**TASMANIA DEPARTMENT OF MINES
UNPUBLISHED REPORT 1987/78**

**Inspection of a proposed subdivision
at Freshwater Point, Legana**

Figure 1

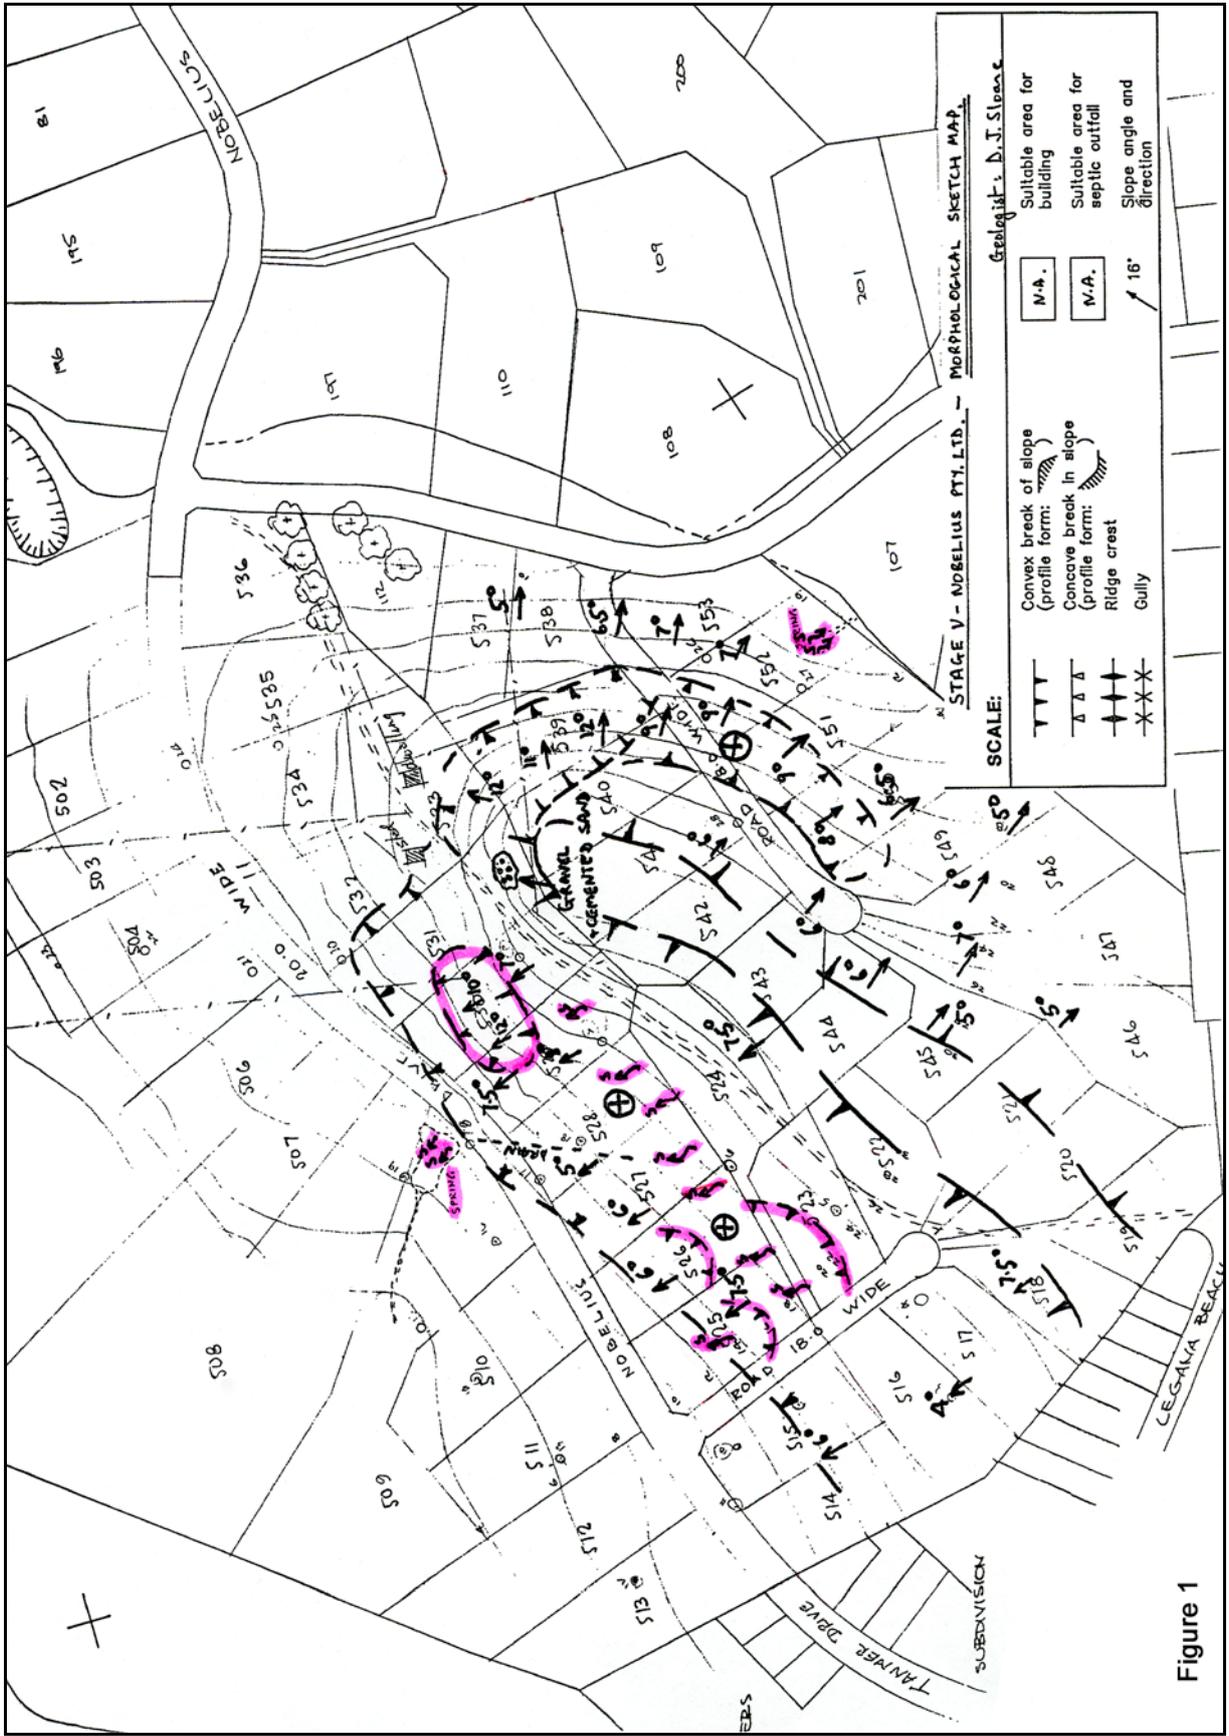
A proposed subdivision at Freshwater Point, Legana has been inspected. The slopes have been classed into three categories on the subdivision plan. Figure 2 shows those areas steeper than 8°. These areas are considered to be potential landslip areas if underlain by Tertiary clay. The ridge crest may be underlain by cemented sand and gravel which can be seen exposed in the small quarry adjacent to the existing dwelling. The steepest slopes occur around the eastern end of the ridge (fig. 1) where slopes of up to 12° have been measured. If these steeper areas are underlain by gravel they can be considered stable. It is therefore considered necessary to determine the stability of the upper, steeper, sections of lots 550, 551, 552, together with the lower part of lot 540 and all of lot 539. The remainder of the southeast facing ridge slopes are considered to be simple in profile with slopes of less than 8°, and are therefore considered stable. No evidence of seepage was observed at the time of inspection, apart from the small seepage area at the base of the slope; this is indicated on Figure 1.

The northwestern facing ridge slopes have a more complex topography with evidence of possible seepage indicated by vegetation. Some morphological features possibly indicate evidence of old shallow earth flows, despite the fact that the slopes are generally low. A small break of slope at the foot of the slope may indicate an old toe feature and small arcuate scarps may be present on lots 525, 526 and 523 (fig. 1). The main morphological feature is a broad shallow hollow with vegetation indicating possible seepage, in the area of lots 525, 526, 527, 528, 523 and 524. A shallow drain extends across the slope on lots 527 and 528. Gravel is exposed on the surface of the steeper part of lot 530, however as the majority of this lot and the adjacent part of lot 531 is steeper than 8° then confirmation of the existence of underlying gravel is required in order to confirm the stability of these lots.

It is recommended that further investigations are conducted in order to confirm the stability of those lots in question. If septic tank approvals are required then the possible area of seepage along the northwestern facing ridge slope should be investigated, especially considering the area may be an old shallow earthflow. It is suggested that further investigations consist of at least three backhoe test pits to depths of about two to three metres. Materials should be inspected and samples taken for analysis.
